# **EXHIBIT M1**

Re: Sewage  
Part II Permit No. 0472402  
Amendment No. 4  
City of Beaver Falls  
Beaver County

We are approving your proposal to enlarge the secondary pump station wet well as outlined in your consulting engineer's February 23, 2010 letter and supporting documentation.

**RE: Beaver Falls Water Pollution Control Plant  
Letter Modification to Water Quality, Management Permit  
WQM No. 0472402-A3, NPDES Permit No. PA0026883**

WET WELL EXPANSION  
LOCATION MAP  
1" = 30'

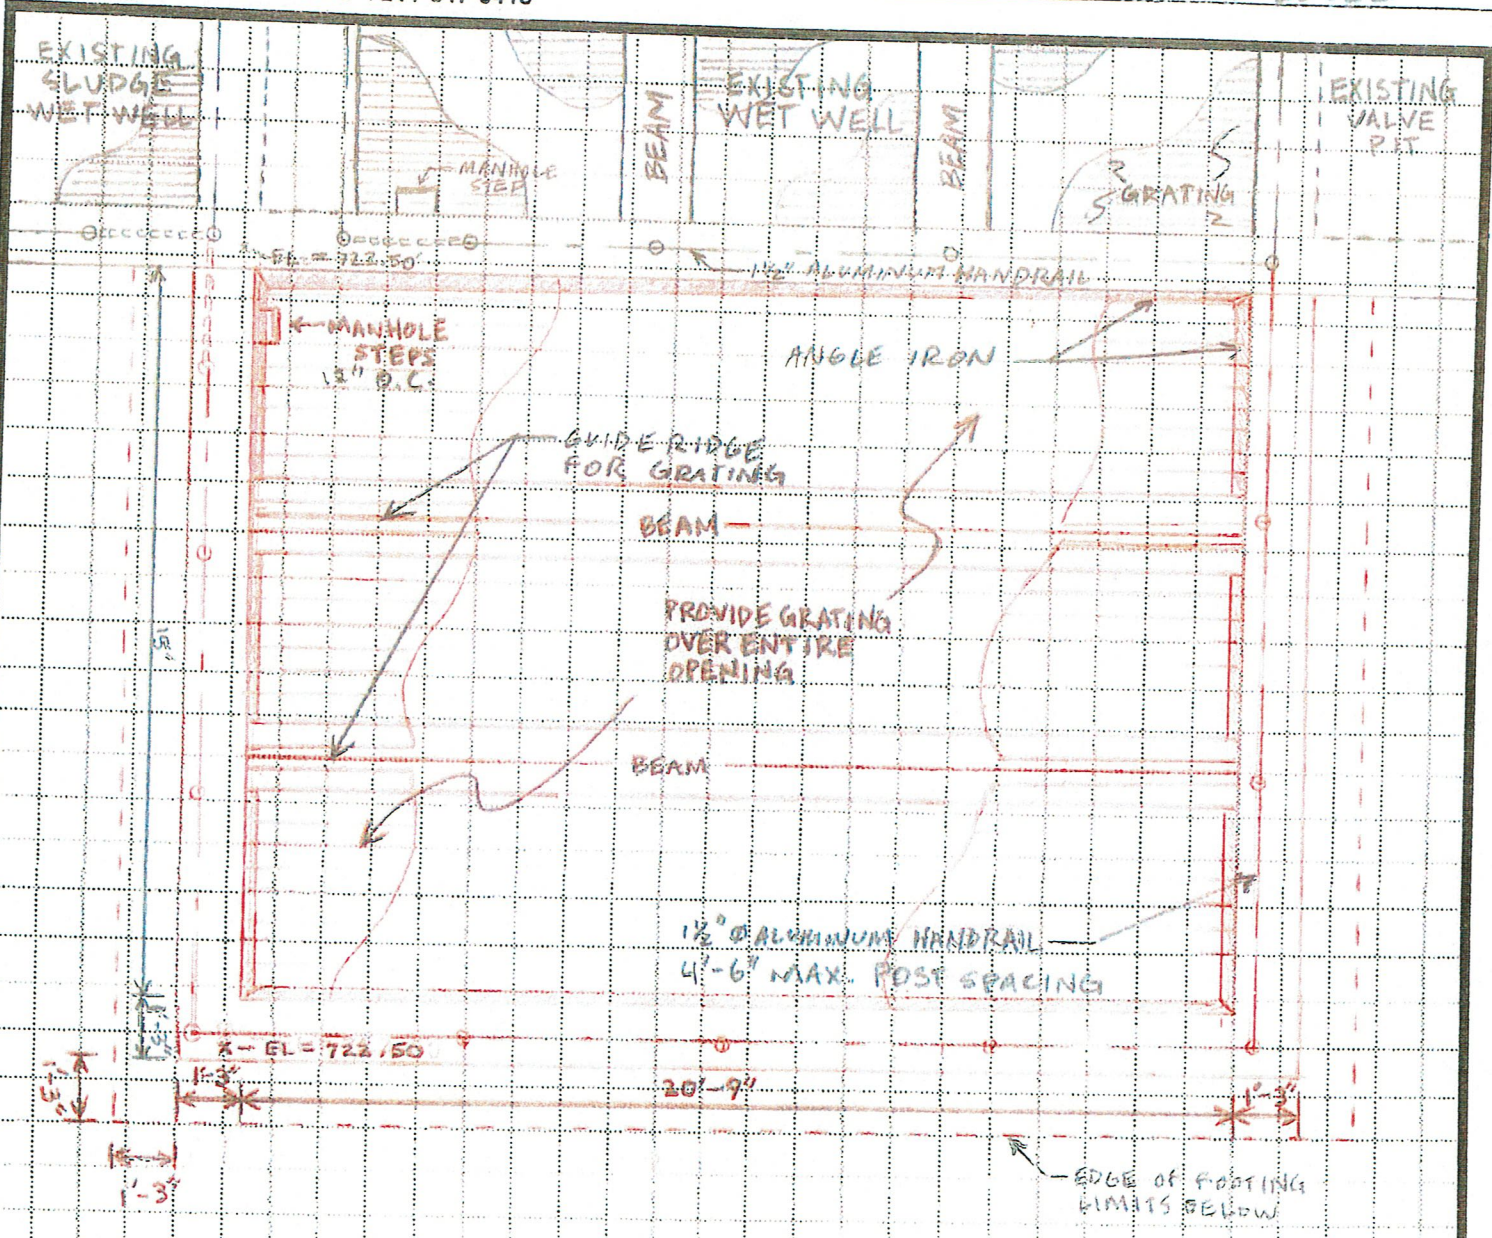
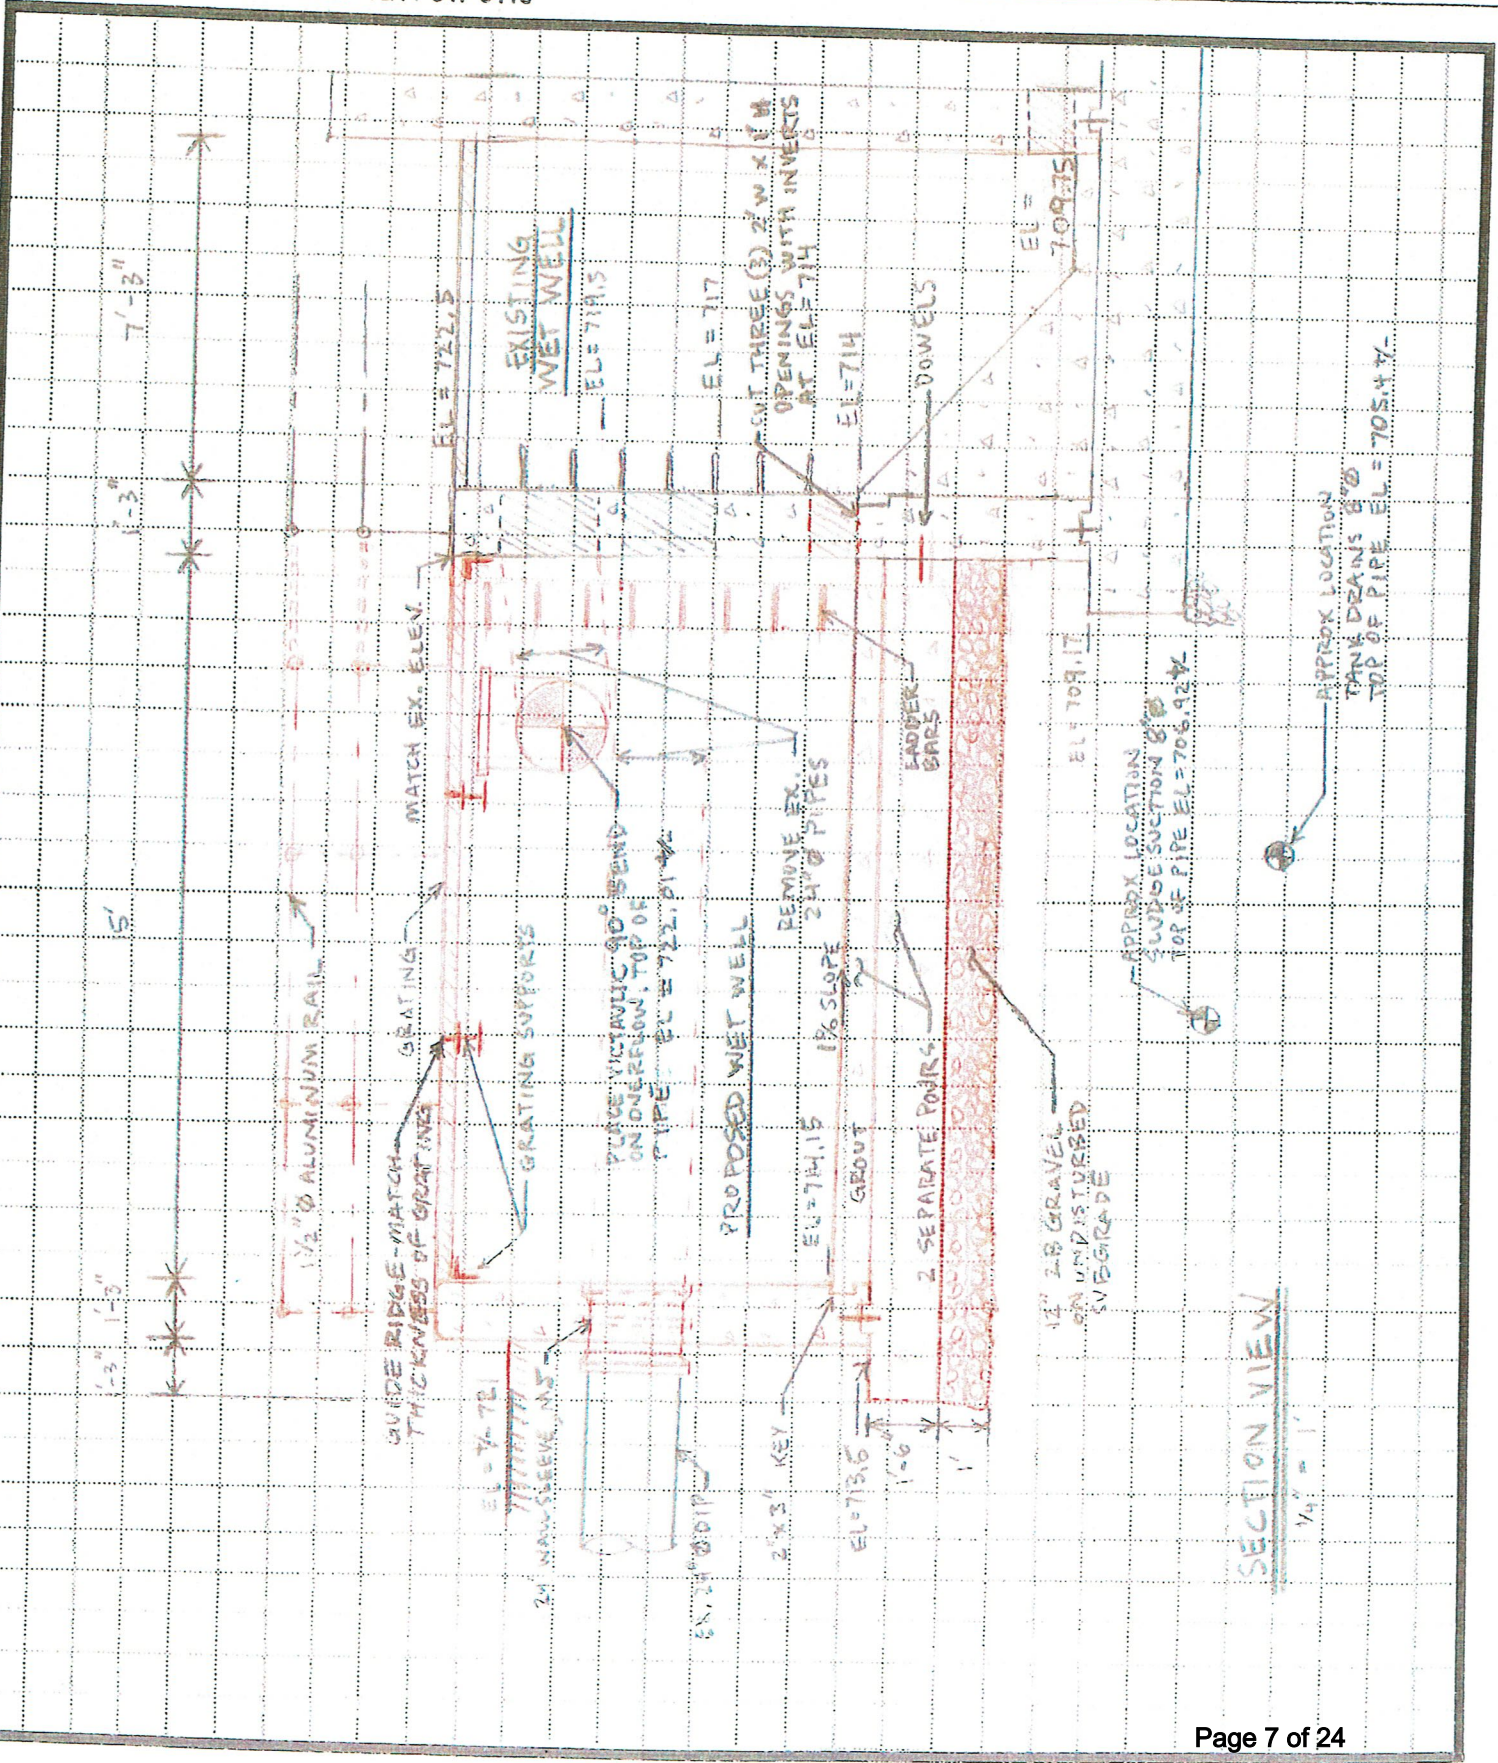
This letter is written on behalf of the City of Beaver Falls to request a letter modification to the City's wastewater treatment plant water quality management permit (Part II permit). I am proposing that the secondary pump station wet well surface area be enlarged in order to optimize pump response to rapid flow increases that occur during rainfall events. Enlarging the wet well surface area will slow the vertical rise of the influent water surface during peak flow periods and allow the automatic pump controls to adjust pump speeds more gently and maintain a stable water surface elevation below the wet well overflow pipe invert.
